PLANNING BOARD AGENDA

AUGUST 16, 2021
REGULAR MEETING ~ VIRTUAL

VI. CONTINUED FORMAL VARIANCE APPLICATION
ROME, ELAN S, TRUSTEE OF THE ELAN ROME LIVING TRUST
(CONTRACTOR CHRIS MOTT BUILDERS)
407 17TH AVENUE
BLK – 6 LOT - 36

**Re: Completeness/Technical Review #2
407 17th Avenue (Mott)
Block 6, Lot 36
H2M Project No. LKCP 2103**

DATE: 11/13/20
DRAWN BY: JM
CLIENT: WALKER RESIDENCE
ADDRESS: 461 SEVENTEENTH AVENUE LAKE COMO, NEW JERSEY
SHEET NO: Z-4
BLOCK: 6 LOT: 56

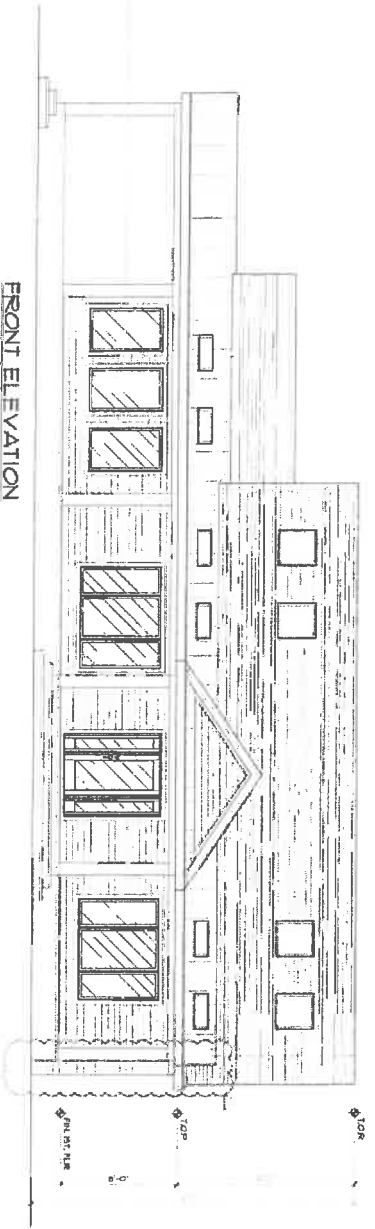
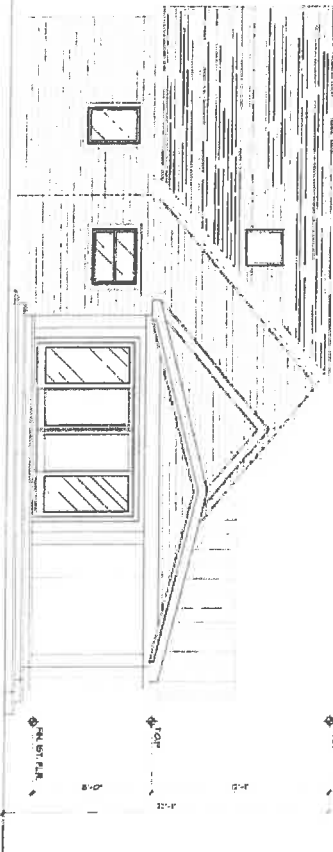
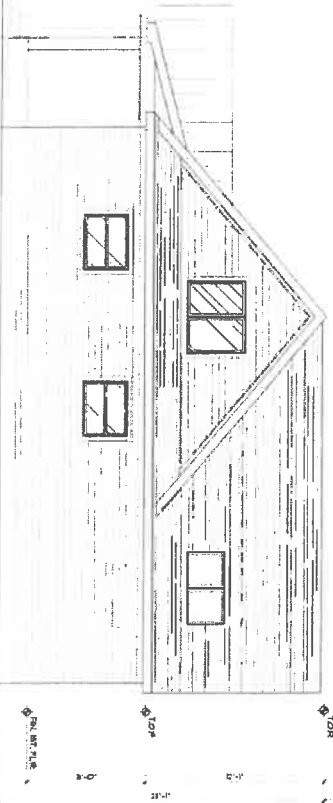
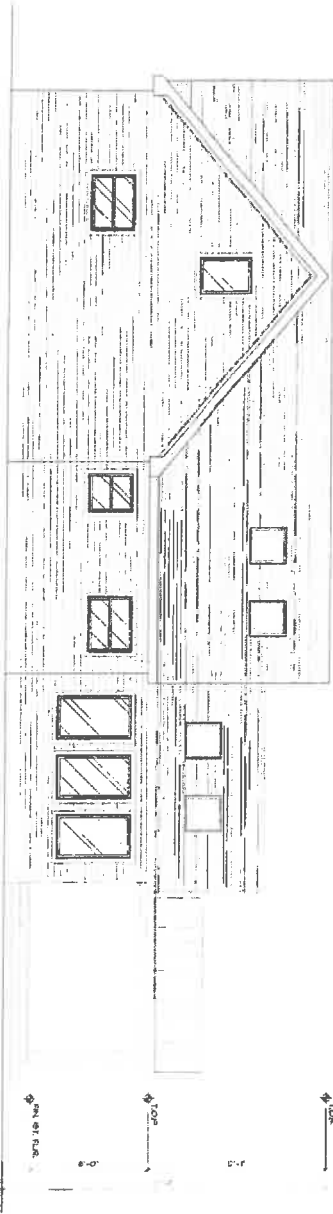
In addition, there is a mixture of terms on the "Site Plan" on Sheet Z-1 of the Architectural Plans does not necessarily square with the impervious coverage calculations of the same sheet. The call out for the proposed driveway refers to a "paver" surface, while the remainder of the proposed impervious surfaces refer to a "paved" surface. These terms have separate and distinct connotations and must be clarified to corroborate the correct impervious cover calculation. Further, the Applicant is taking benefit of the 50% reduction through the use of pavers, but is silent with regard to the type of paver and the construction detail to be used to construct said pavers which will allow for infiltration of stormwater to the subgrade below. The Board should elicit testimony regarding these two items and require the plans be amended accordingly.

6. **The survey and floor plans provided show a Bilco Door on the Wooley Lane side of the existing dwelling; however, this feature is not depicted on the Site Plan, and will likely conflict with the proposed paved walk. The Applicant should provide testimony regarding this issue.**
7. **The Artist Rendering on Sheet Z-1 of the amended architectural plans depicts some sort of superstructure over the proposed patio while the "Site Plan" on the same sheet identifies a proposed outdoor grill area without any sort of superstructure. The Board should elicit testimony regarding this discrepancy and consider any further relief necessary in the event the Applicant is proposing said superstructure.**

1. The driveway will be completely made of pavers.
2. The Artist Rendering on page Z-1 shows a trellis which will be removed.
